SITE OBSERVATION REPORT

Project:	Equinix CL1 Mantrap	Project No:	2201319
Location:	Calgary, AB	Report No:	1
Contractor:	Ellis Don	Date of Visit:	2025-09-02
Building Permit No:	BP2024-00799	Report Date:	2025-09-09
		Sheet:	1 OF 4

Reason for Site Visit: Final Review

Figure 7 - Sprinkler Data Center Side of Double Door

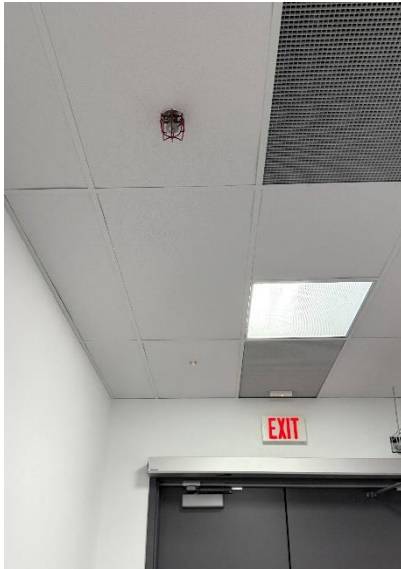
2.1 During the site observation, it was noted that the two sprinkler heads which were issued as part of the revised drawings have not been installed. The issued package, identified as *GC-M-PC-007* dated 2025-06-23, required sprinkler heads to be added on either side of the double doors (Reference sheet F120 – Android L&F Phase 2, Mantraps Replacement, Bankers Hall, 315-8th Avenue S.W., Calgary, AB). These additions were indicated on the drawings; however, they were not observed on site. The Contractor is requested to review and confirm the installation requirements, with a plan for corrective action.

- Drawing reference: Sheet F120
- Issuance reference: Issued for GC-M-PC-007, dated 2025-06-23

Figure 9 - Exit Sign to be Demolished

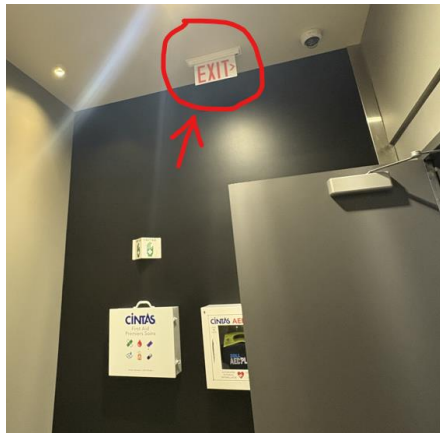
- 1.1 During the site observation, it was noted that an existing exit sign scheduled for removal, located at the end of Corridor-1, has been disconnected but not yet demolished (refer to figure below). Electrical contractor shall provide photographic evidence upon completion of associated demolition and patching.
